MODIFICATION RECOMMENDED –
CORRECTS MANUFACTURING OR DESIGN DEFECTS

SN-1730B -01

S E R V I C E N O T E

1730B 1/2G Fibre Channel SAN Tester

Diagram 1:

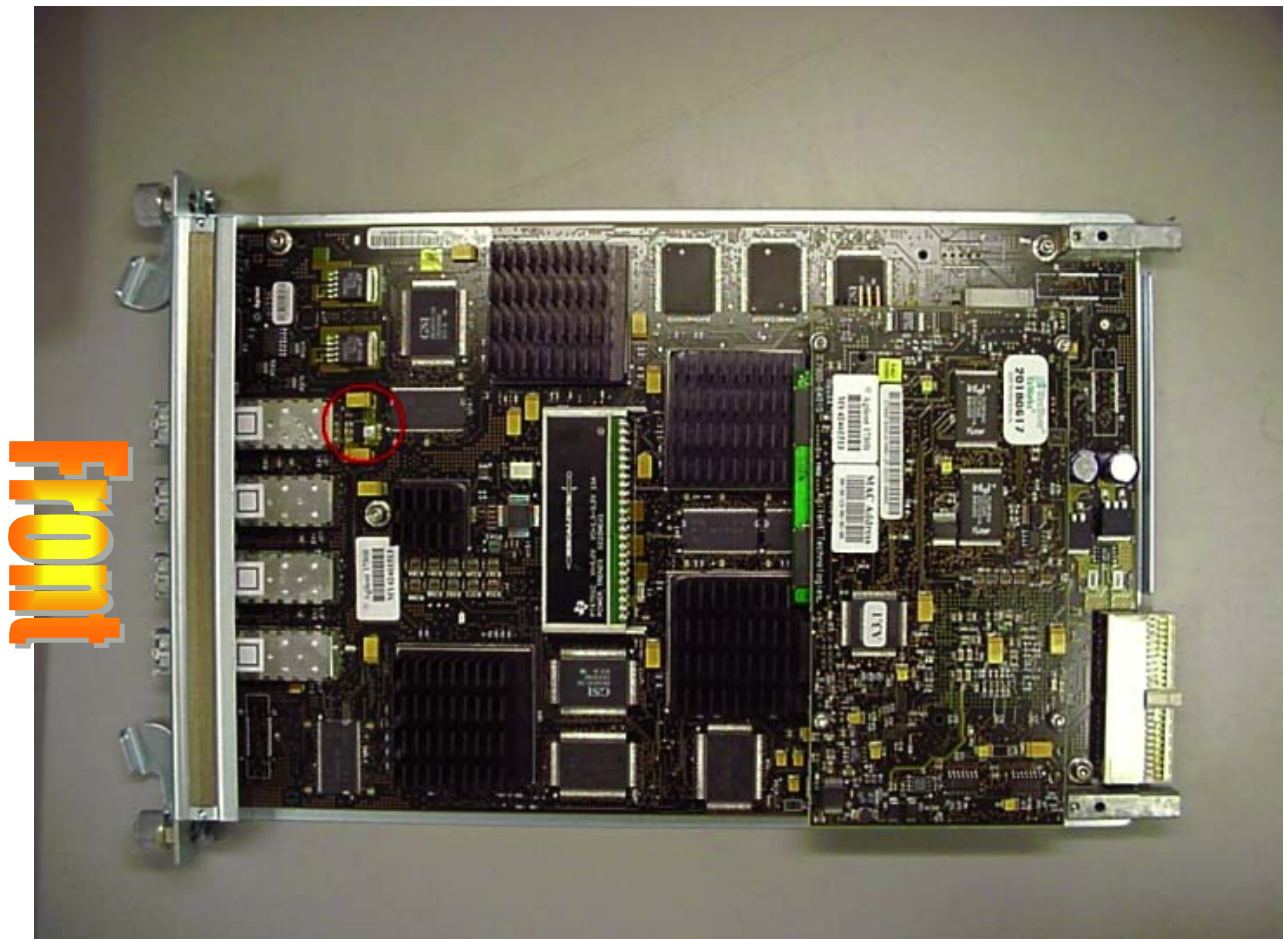
The “front” of the 1730B module is defined as the side with optical connectors. See Diagram 1

1730B 1/2G FC SAN Tester. Note general location of resistor and capacitor.

Diagram 2:

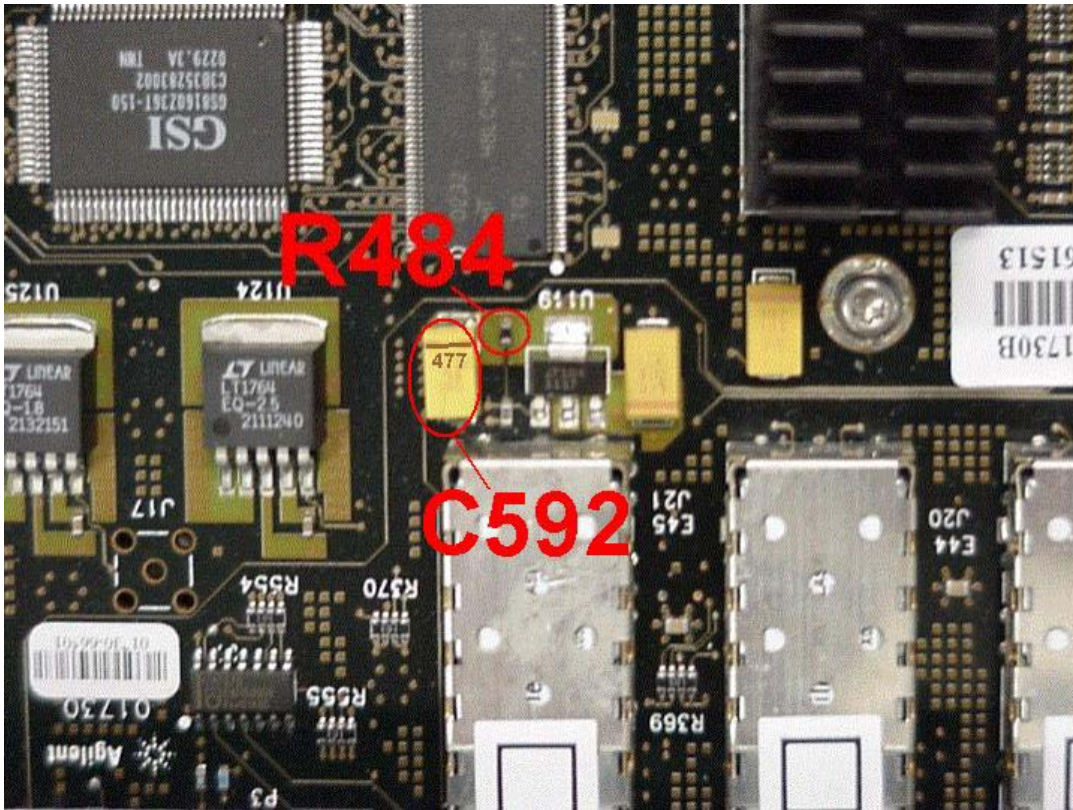
- **Surface mount resistor designated R484 is the wrong value and can lead to system hangs, crashes or report of disparity errors.**
- **Surface mount capacitor designated C592 MAY have the wrong value and can lead to system hangs and crashes**

Resistor R484 (see picture below) needs to be changed **from** PN-0699-3926 (121 ohms) **to** PN 0699-3911 (26.1ohms).

Visually inspect Capacitor C592 (see picture below). If value on capacitor is 476, then the capacitor needs to be changed **to** PN 0180-4976. Capacitor polarity must be respected. If the value on capacitor is 477, the capacitor does NOT need to be changed.

- 1) Remove resistor and replace it with 0699-3911. (see Diagram 2) One side of this resistor is connected to a power plane, so soldering the replacement resistor can be problematic. Inspect solder connections thoroughly to ensure a solid connection. You may want to re-flow the solder after the resistor is initially soldered down. You may have to use a higher -than -typical wattage solder tip to re-flow the solder.

- 2) Test for a good solder joint measuring the resistance between the replaced resistors front lead (that is the lead facing the front of the board) and the positive side of the capacitor directly next to the resistor. (Same capacitor referenced above). It should read about 26 ohms.

- 3) If capacitor needs to be changed, replace it with 0180-4976. The brown bar on the capacitor is oriented towards the “back” side of the board (see picture)
Inspect solder connections thoroughly to ensure a solid connection. You may want to re-flow the solder after the capacitor is initially soldered down.

Diagram 3

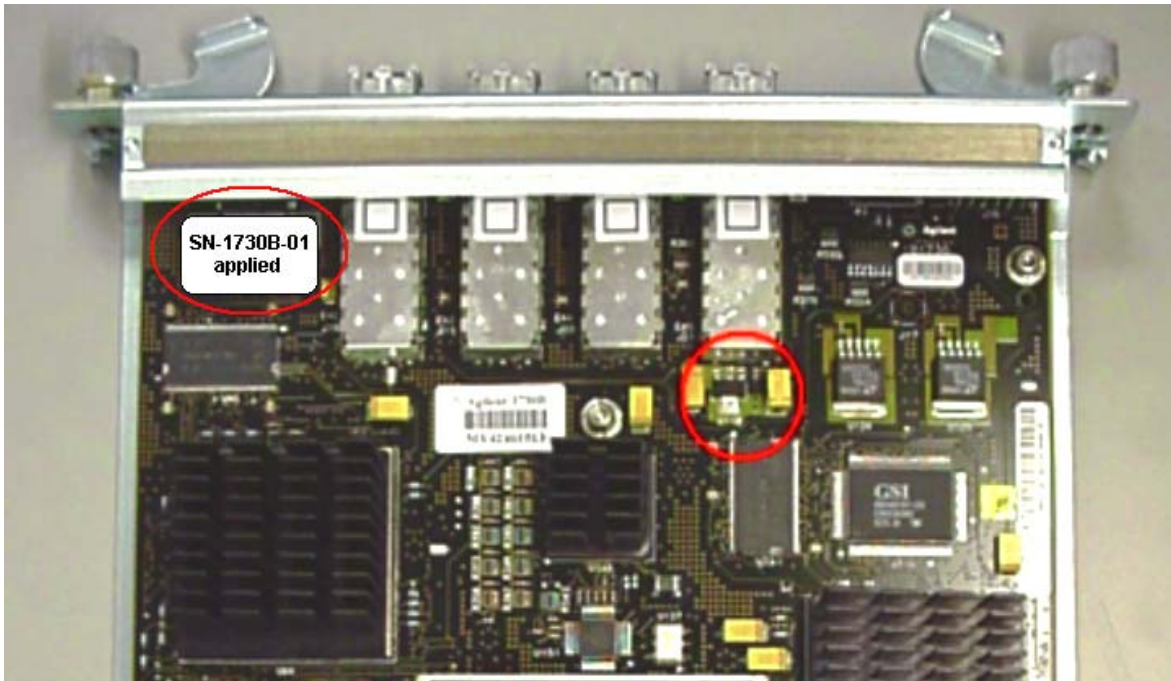
- 4) Attach Service Note Sticker . See Diagram 3
